**CALIFORNIA COASTAL COMMISSION**

**Item M8e****STAFF REPORT: REGULAR CALENDAR**

**APPLICATION NUMBER:** 5-01-162

**PROJECT DESCRIPTION:** Construct 7.5-foot high masonry block wall in public right-of-way.

E-3

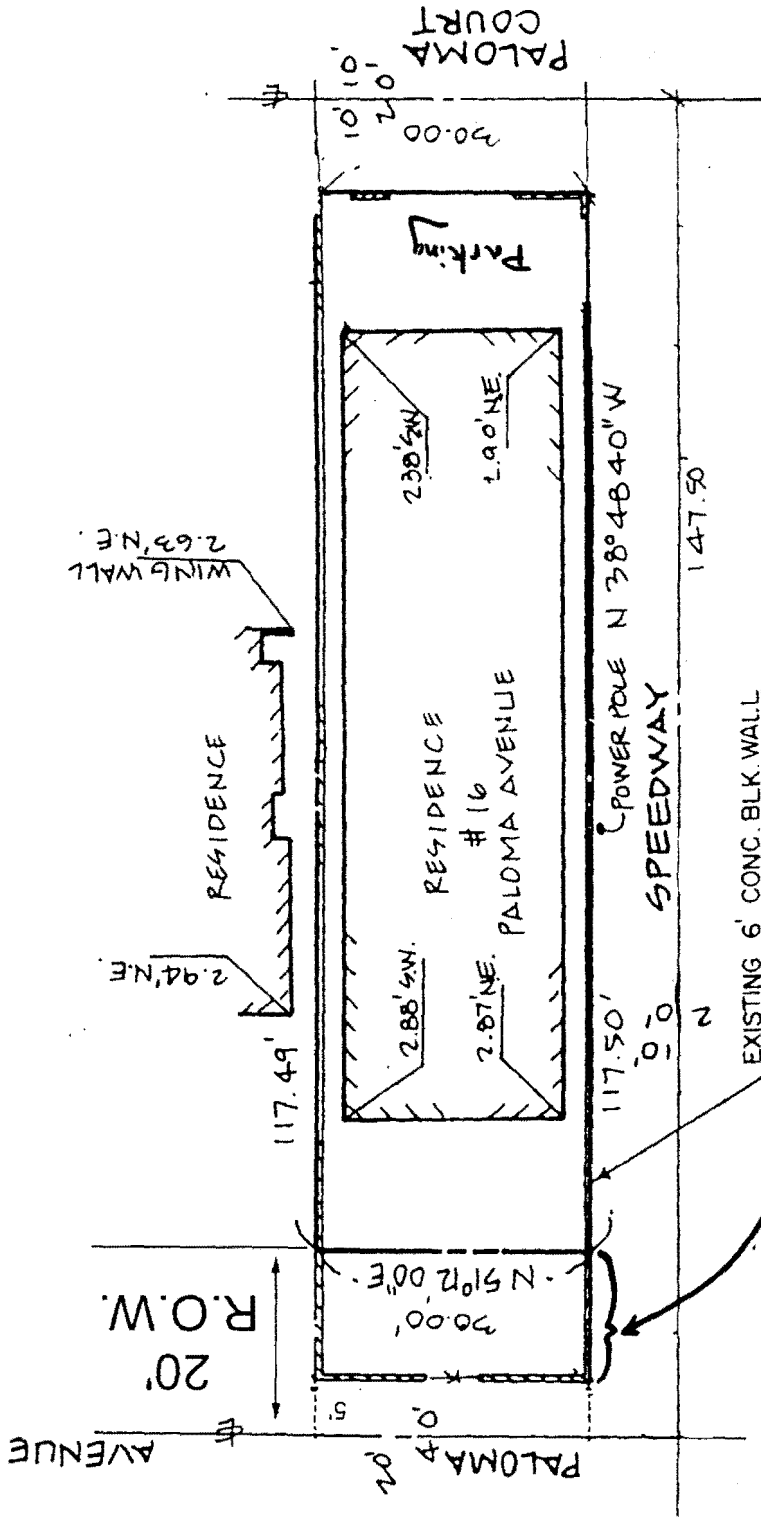
Proposed 7 1/2' wall in Public right-of-way (3 sides).

1. The wall shall be permitted along the perimeter of the site as shown in exhibit E-3.
2. The height of the wall shall not exceed 7-foot 6 inches as defined by the Department of Building and Safety.
3. The wall shall be constructed from masonry blocks with a gate access located along Paloma Street (walkstreet).
4. The portion of the wall fronting Paloma Street shall have a creeping vine planted on its facade.
5. Landscaping along Paloma Street shall included an automatic irrigation system, and maintained in accordance with a landscape plan prepared by a licensed landscape architect or licensed architect.
6. The applicant shall obtain a revocable permit from the Department of Public Works as required by the Venice Specific Plan, to permit the wall/fence in the public right-of-way.

Exhibit #5

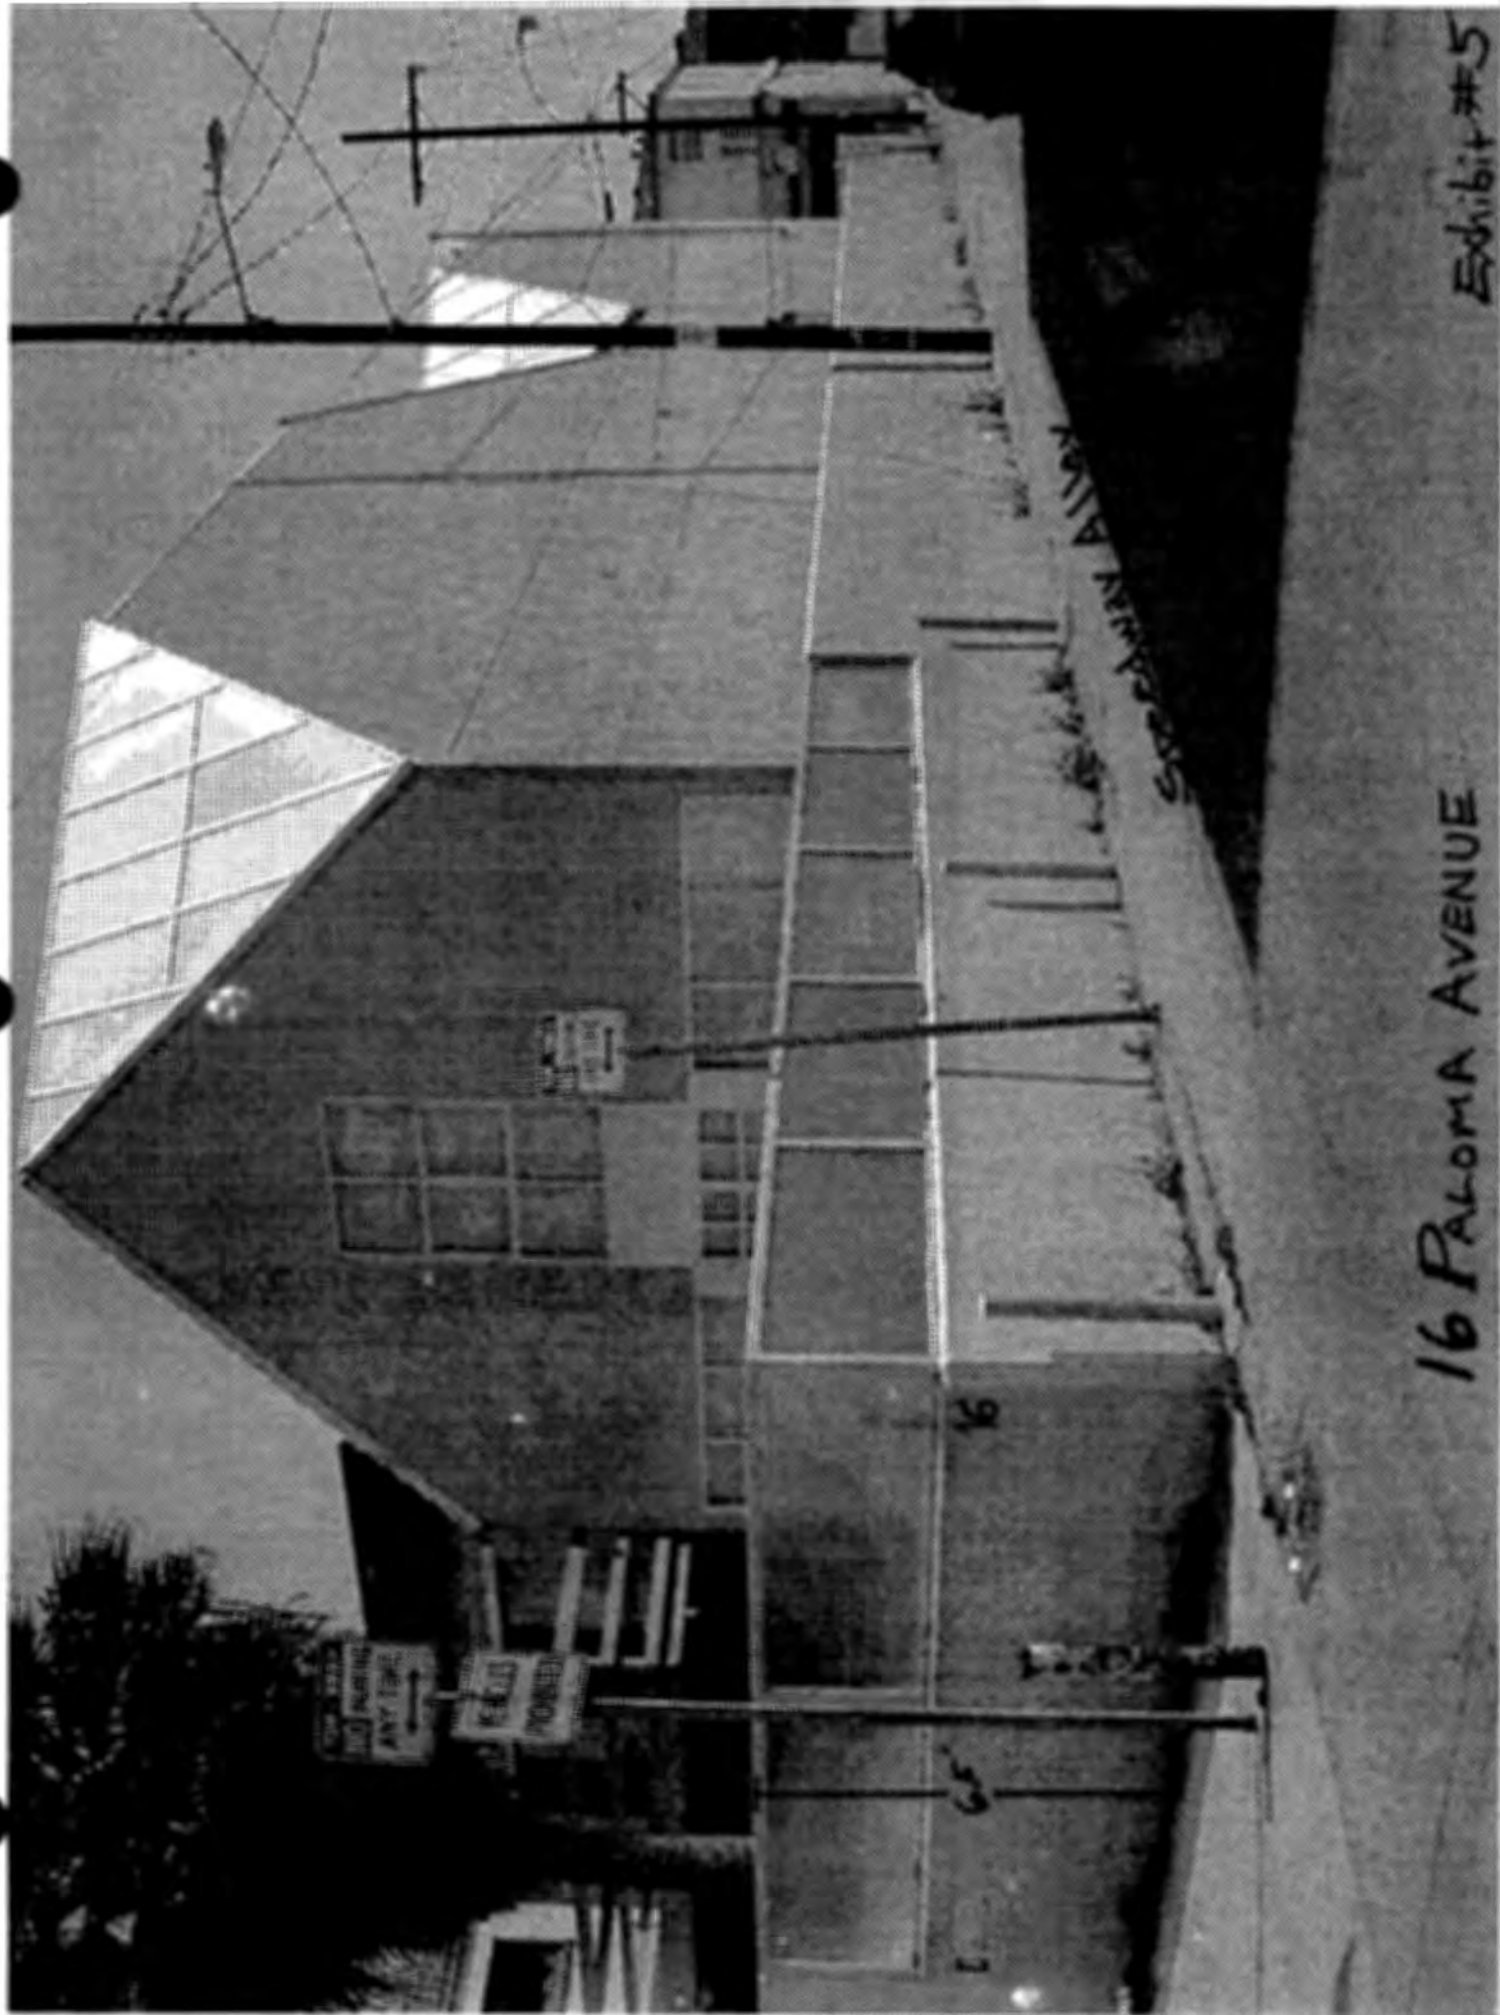
A 6.5-foot high wall currently exists on the site, enclosing the front yard and a 15'x 30' portion of the 40-foot wide Paloma Avenue public right-of-way (Exhibit #5). The existing single family residence was built in 1983 pursuant to the Commission's approval of Coastal Development Permit 5-82-447 (Sohn). The 6.5-foot wall that exists on the site was not approved by Coastal Development Permit 5-82-447 or any other Commission action. It is an unpermitted development.

16 PALOMA AVENUE

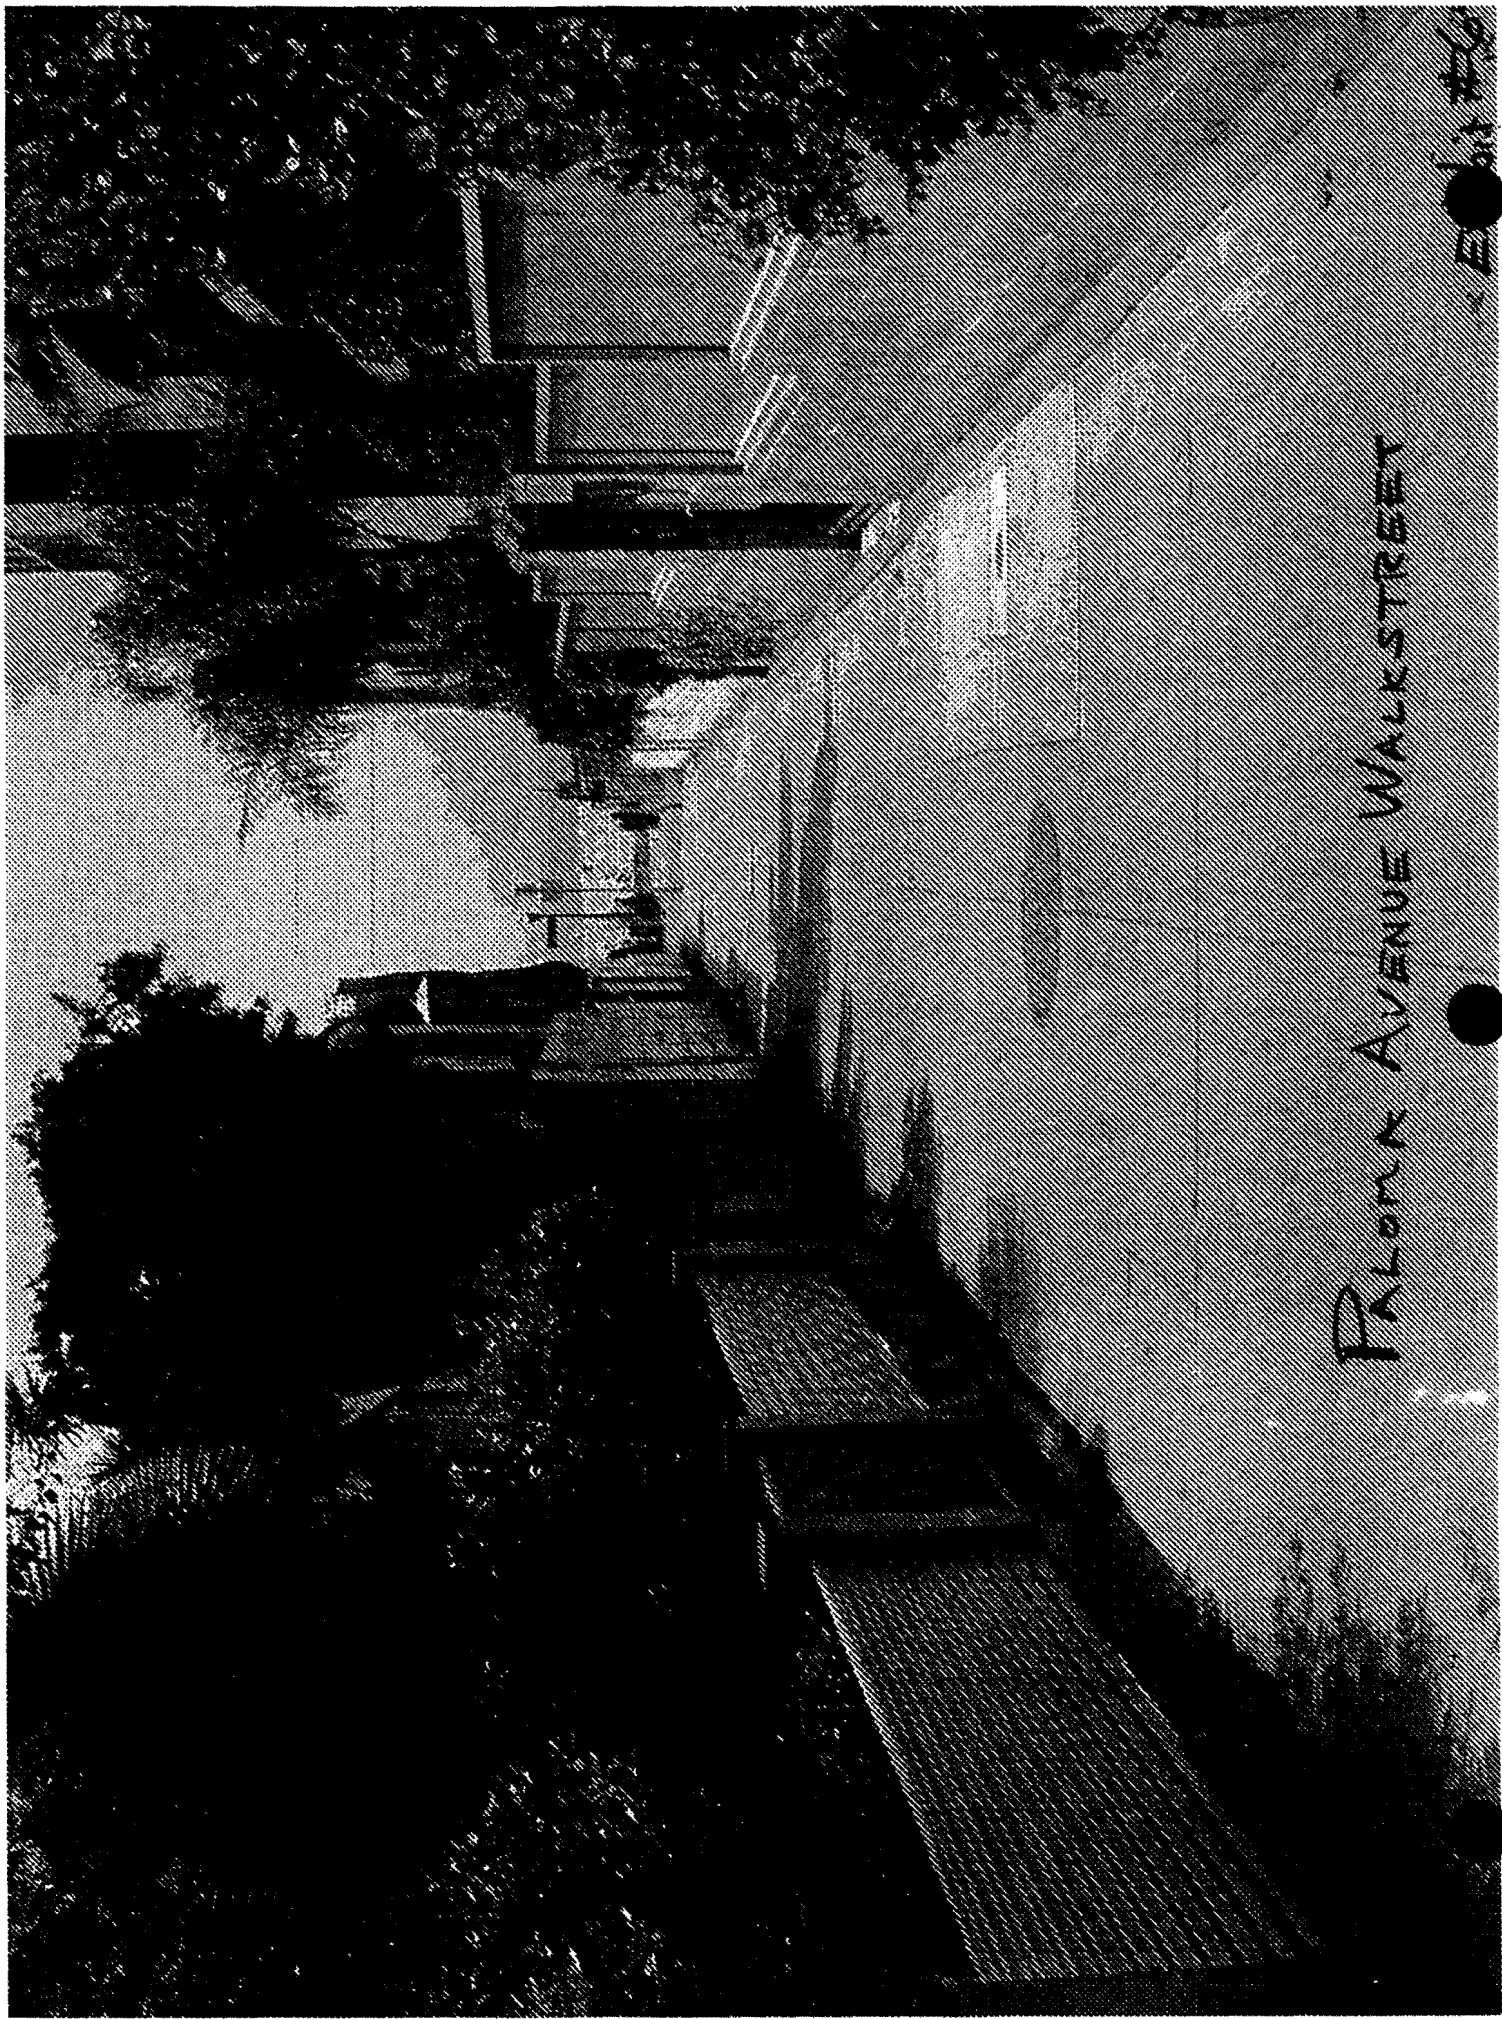
A public view of the shoreline exists from the Paloma Avenue walk street (Exhibit #6). The proposed 7.5-foot high wall would partially obstruct the public view of the shoreline from Paloma Avenue (Exhibit #6). The proposed 7.5-foot high wall would have a negative effect on community character and the special character of the walk streets themselves by obstructing public views of the public right-of-way. Policy II.C.11 of the Venice LUP states that the right-of-way area of the walk street between the fences and the buildings, into which residential yards are encouraged to encroach upon, is a transitional zone between the public path ways and private dwellings. While the public may be excluded from physically accessing the encroachment areas, the landscaped right-of-way still provides the public with a unique visual resource and a feeling of openness along the accessway. The proposed 7.5-foot high wall would eliminate any transitional zone from the public accessway and, if allowed on every encroachment, would result in an accessway lined with looming canyon-like sides.
